Subject: Class 1 Permit Modification to Add Structure to the Los Alamos National Laboratory (LANL) Hazardous Waste Facility Permit, EPA ID #NM0890010515

Enclosure: *Hazardous Waste Facility Permit Class 1 Permit Modification for Addition of a Structure to Technical Area 63*

Class 1 Permit Modification Addition of a Structure to Technical Area 63, Los Alamos National Laboratory Hazardous Waste Facility Permit

Figure G.27-1. Transuranic Waste Facility Soil Sampling Grid

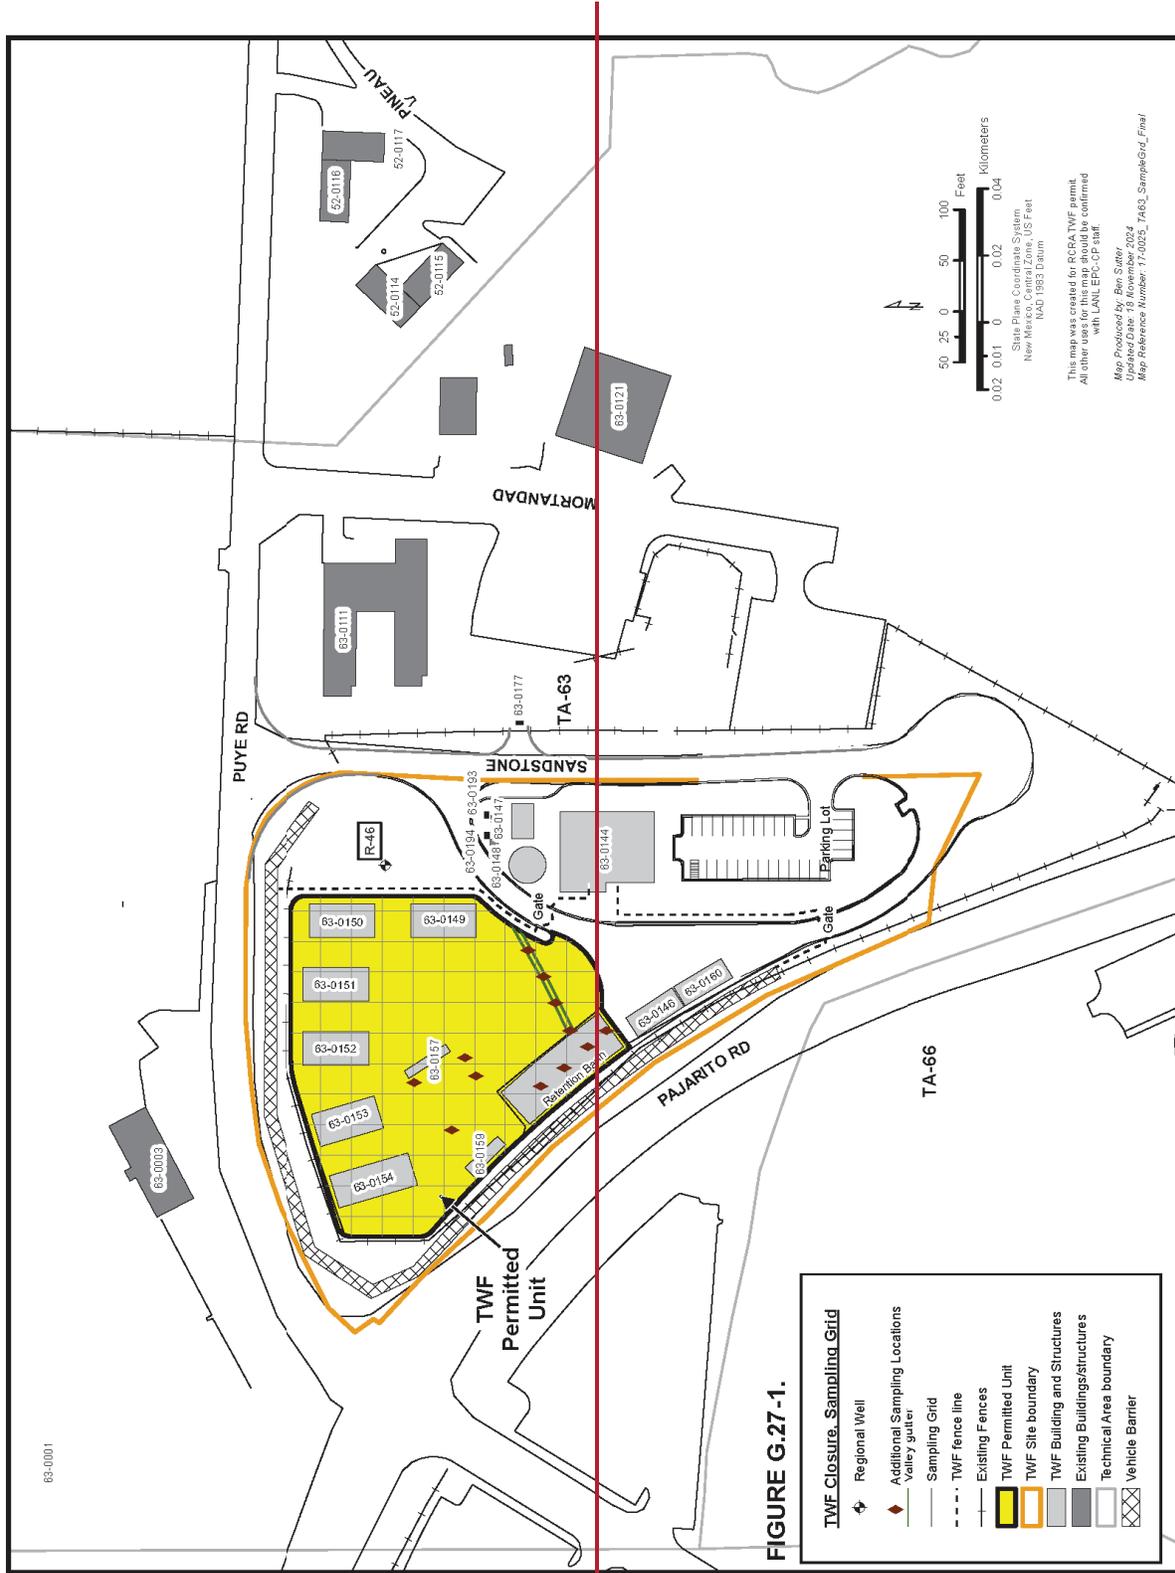
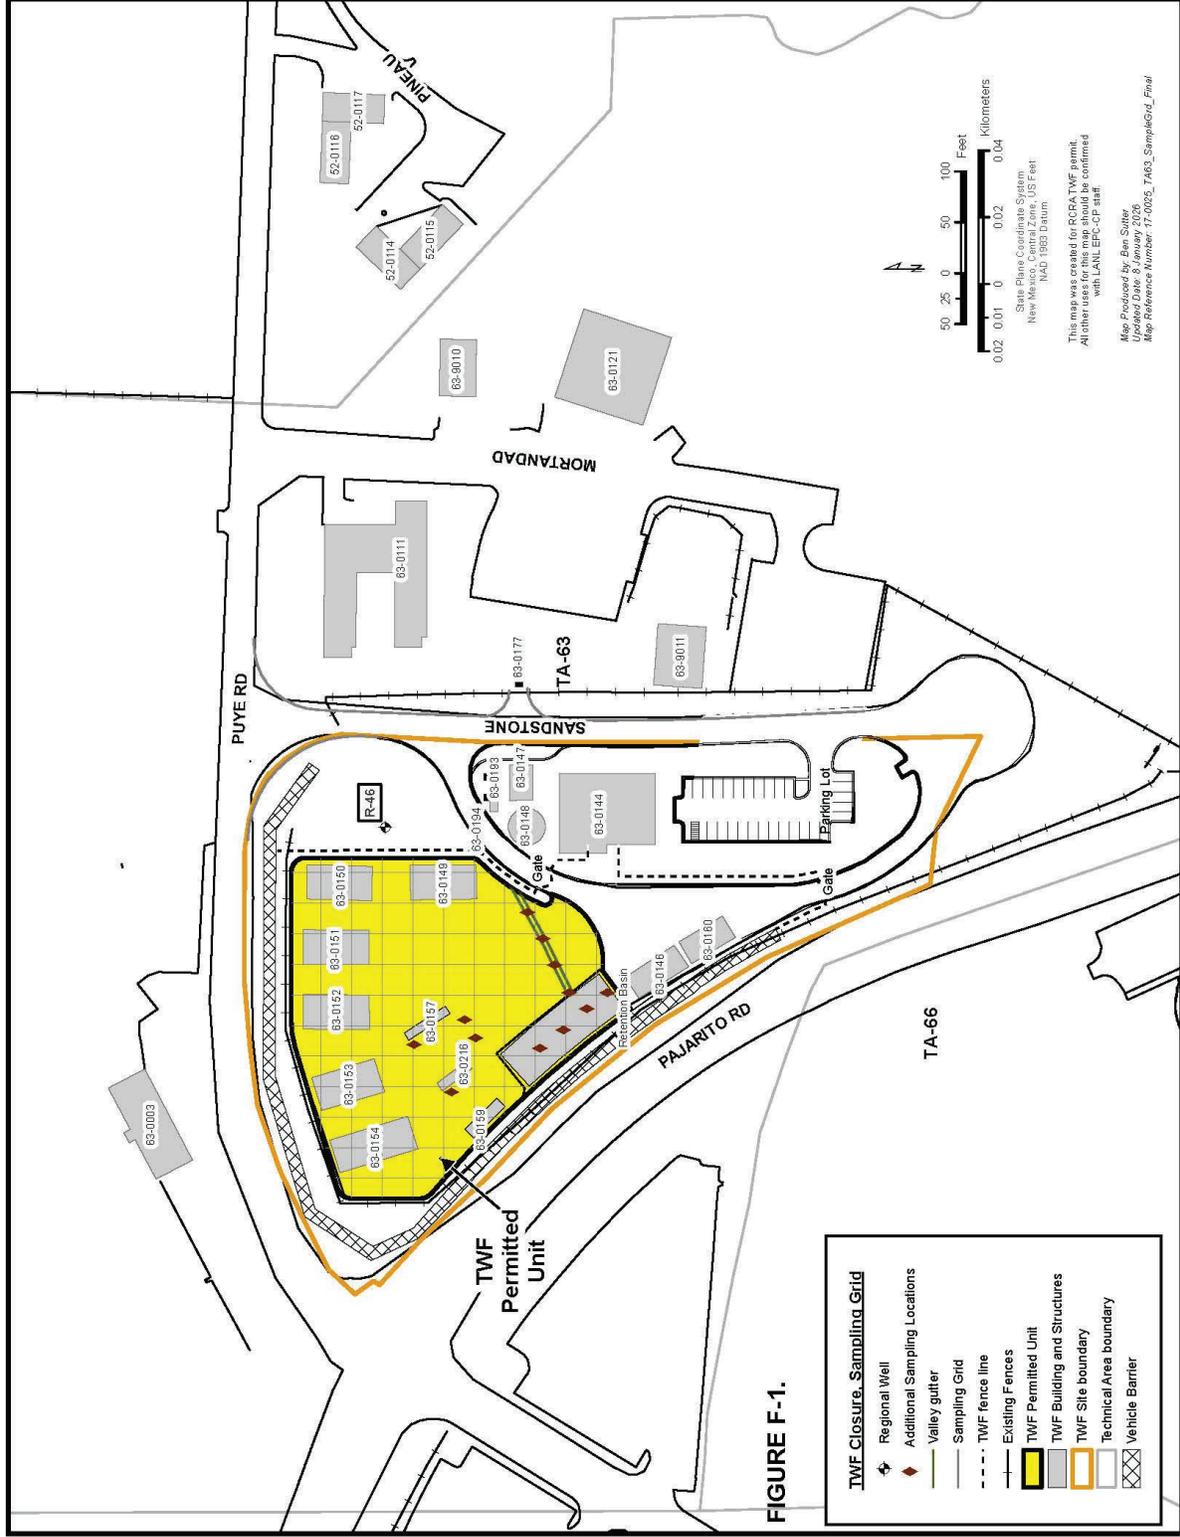
Attachment G.27, Technical Area 63, Transuranic Waste Facility Closure Plan, revision reflects the addition of structure RTR-9 to the description of unit to be closed, a correction of a typographical error for the Calibration Source and Matrix Module building from structure “63-0158” to “63-0159”, and an updated Figure G.27-1 is provided.

Figure 56

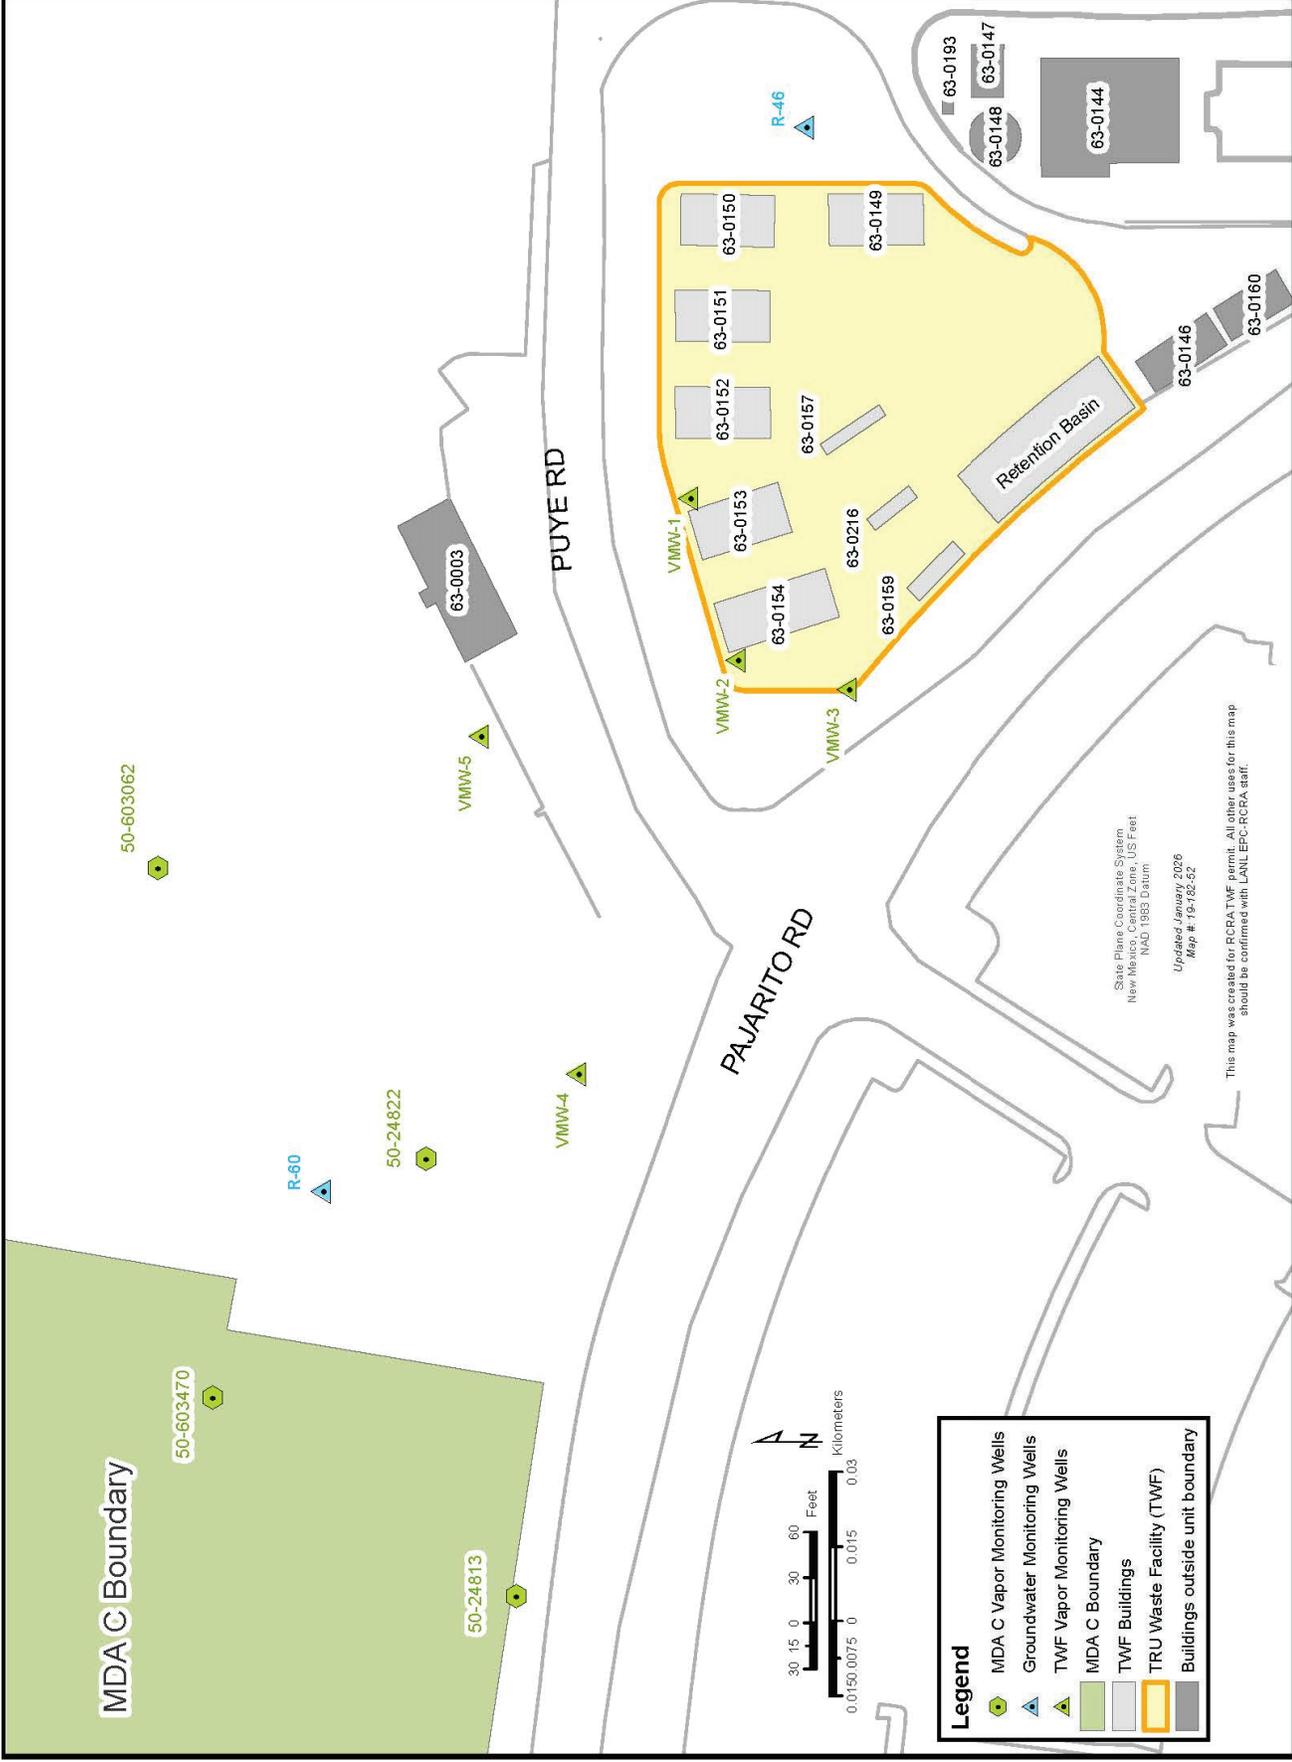
Attachment N, Figures, revision reflects the addition of structure RTR-9 to Figure 55, Technical Area (TA) 63 Transuranic Waste Facility, and Figure 56, Transuranic Waste Facility Subsurface Vapor Monitoring Network. Additional updates were made to Figure 56 to remove the word “proposed” in the legend of the map. Please note that this figure has been recreated by the Permittees, as the original was not generated in house.
